# Traffic Impact Assessment

Werrington Subdivision

Prepared for Lendlease

Version	Effective Date	Description of Revision	Prepared by	Reviewed by
1	2/10/2019	DA Submission	Sabal Sharma/Christos Apostolopoulos	Hayden Calvey
2	25/03/2020	Post DA – Response to Submissinos	Christos Apostolopoulos	Hayden Calvey

Figure 7-1 2019/2020 intersection performance summary

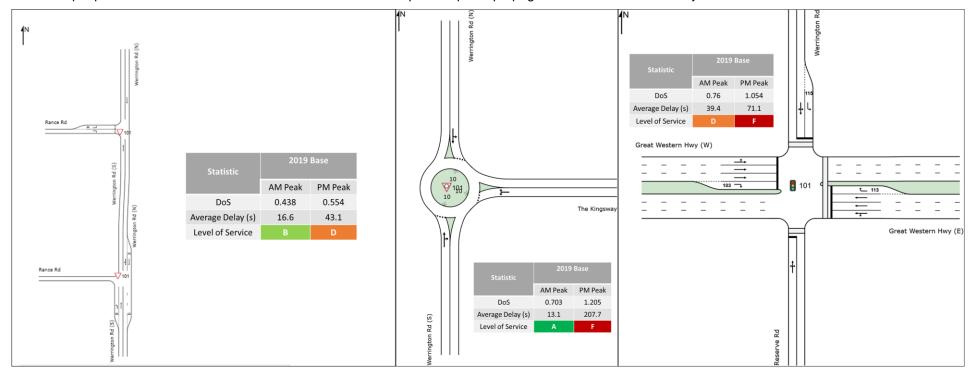
22	Please note that all previous DAs for SWUV precinct required provision of a roundabout at Rance Road / Werrington Road and your LLTR with the lower traffic numbers identifies the need for a roundabout at the first stage. Consequently, any proposal to not provide a roundabout here at first stage or any part of first stage would require strong justification for consideration. Please also note that we need the intersection with first stage to function satisfactorily at the 2030 year horizon because this is normal development timeline practice and will allow for the potential of this being the only stage developed by this time.	Traffic modelling is as per the Council request. The three legged roundabout performs satisfactorily for Stage 1 development.
23	The first stage assessment is requested to also assess/SIDRA traffic model traffic impacts at Werrington / The Kingsway, Werrington Road / Great Western Highway and Werrington Road / Christie Street at 2030. If it is found that the "without development" traffic impacts have a low level of service for any traffic movements and that the with development impacts do not significantly further reduce the level of service for any traffic movements and that any improvement would not significantly improve this or be feasible and so could be accepted awaiting Werrington Arterial Stage 2 by Tens (RMS). Then this is requested be set out in the LLTR for	Intersection modelling shows the existing performanc of The Kingsway and Great Western Highway junctions with Werrington Road will perform unsatisfactory under the Base and Approved development scenarios. The proposed Lendlease development will not result in significant increase to these delays and is generally in line with the Approved development scenario.

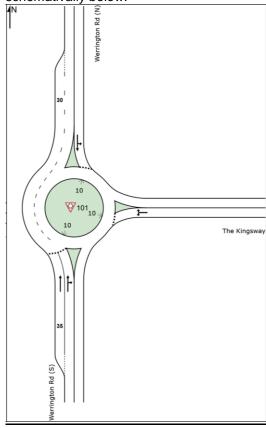
At the request of Council, mitigation of the Werrignton Road / The Kingsway roundabout junction was investigated in order to try and achieve improved LoS. The existing road corridor in this location is relatively tight, with little available road reserve to provide additional lane capacity. The mitigation tested is the provision of an additionl northbound through lane long Werrington Road (short lane only). This is shown schemativally below.

The intersection modelling results, based on the ultimate Lendlease development, are summarised below.

RANCE ROAD/WERRINGTON ROAD INTERSECTION DESIGN

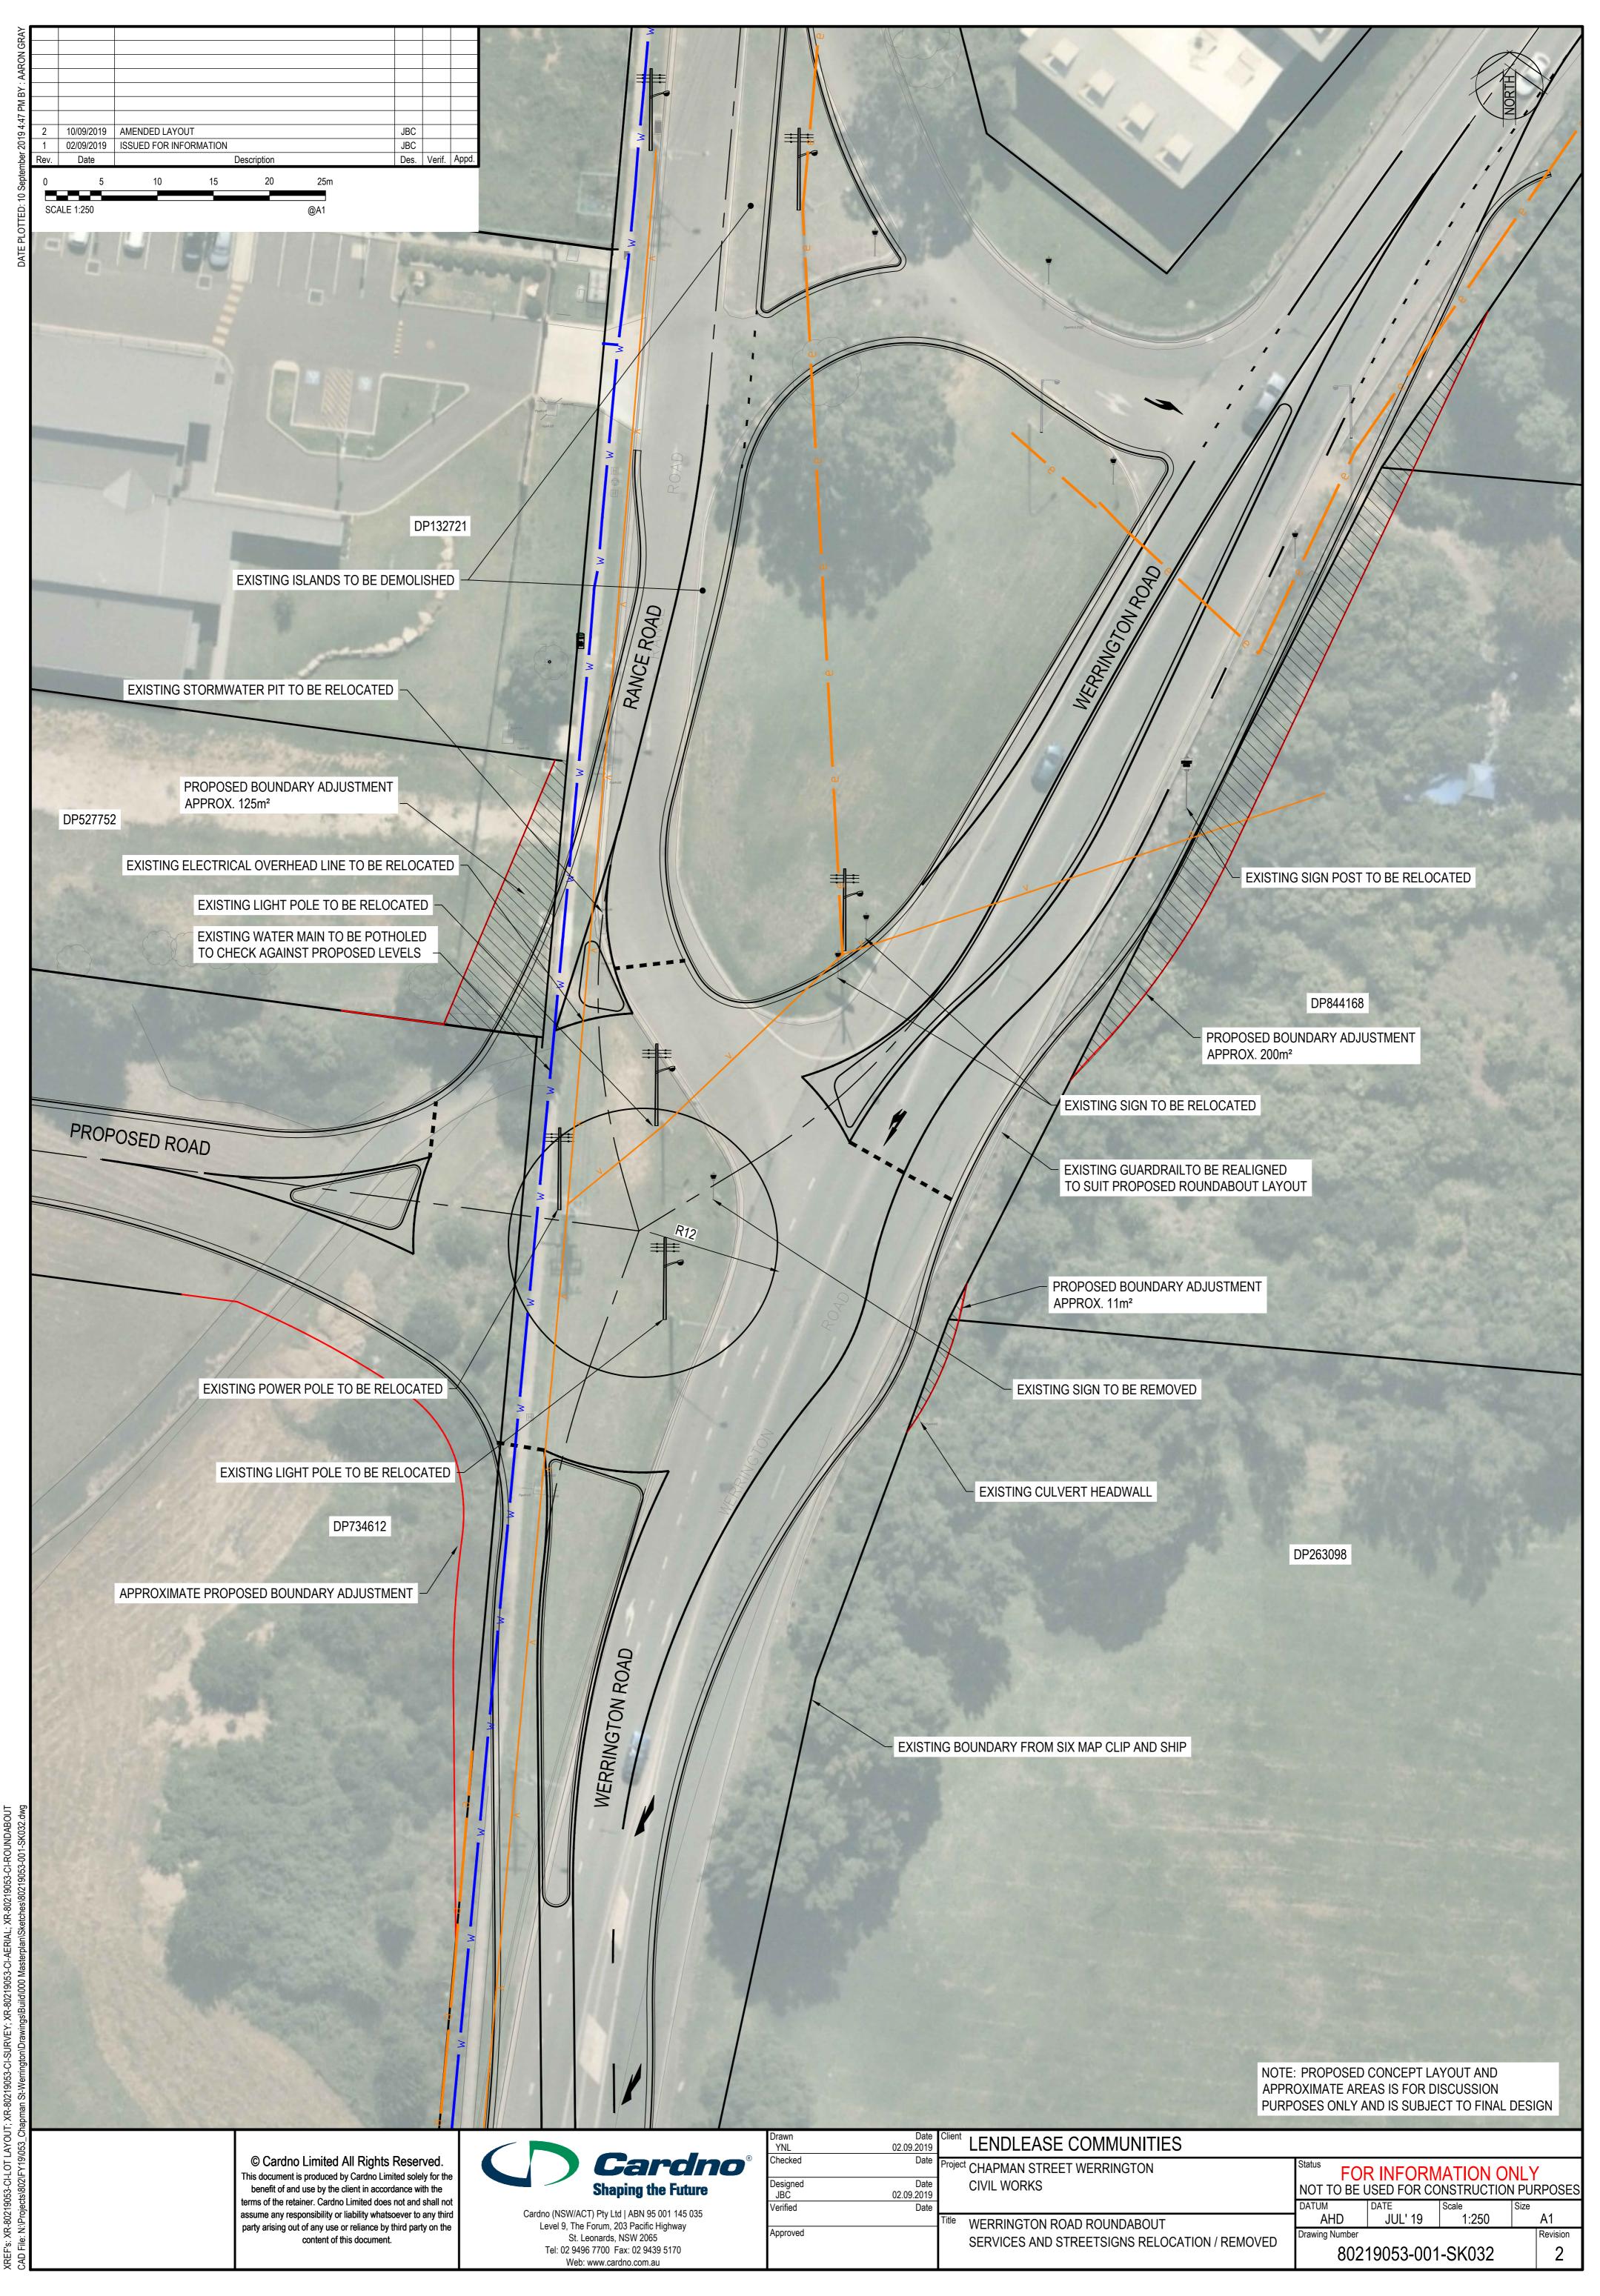
26	The proposed alignment of the proposed roundabout by extending the East West Connector Road directly east to join Werrington Road / Rance Road rather than alignment of the East West Connector Road to connect with realigned Werrington Road/Werrington Arterial Stage 2 as set out in the SWUV DCP plans and the TfNSW (RMS) concept plans for Werrington Aerial Stage 2 is requested to be justified to allow consideration by Council and the RMS. Please note that RMS Land Use Section referral response to Council set out that their position was that the East West Connector Road should be located as set out in the SWUV DCP and in RMS concept plans including realignments of the intersection to the south of Rance Road and realignment of Werrington Road to meet it.	This is addressed by GLN Planning	
27	The points raised at out Council / Lend lease meeting regarding this are appreciated, including that since the Werrington Arterial Stage 2 is not proposed to be provided by TfNSW (RMS) within any timeline and there are no designs for these works that it is more feasible/practical for the LL SWUV DA development to connect to the	This is addressed by GLN Planning

existing Werrington Road and that further realignment of the East West Connector Road and connection to a future Werrington Arterial Stage 2 alignment to the south ( at a proposed signalised treatment) could then be addressed by TfNSW (RMS) at that time. The proposed LL SWUV roundabout would allow for TfNSW (RMS) construction clear of traffic and then the Rance Road / Werrington Road roundabout could be replaced with a left in / left out at Rance Road. It is requested that this position / strategy be set out in the LLTR and include a concept plan showing this possible future arrangement. This will allow further liaison with the RMS Land use Section on this matter and the intersection assessment matters.	
Transport	for NSW – 24 January 2020 letter	
28	It is understood that the vehicular access is proposed through the existing connection via Walker/Chapman streets and a new link road (Road 11) passing through the subject site to connect with Werrington Road. The alignment of Road 11 and its design is not in accordance with the south Western Urban Village (SWUV) structure plan in Council's DCP. The SWUV structure plan shows a road connection further to the south that has connectivity outside of the village.  It is noted that the eastern extent of the alignment is proposed to be straightened to create a fourth leg of a proposed new roundabout on Werrington Road. TFNSW would only support one intersection in the ultimate arrangement as per the DCP.	This is addressed by GLN Planning
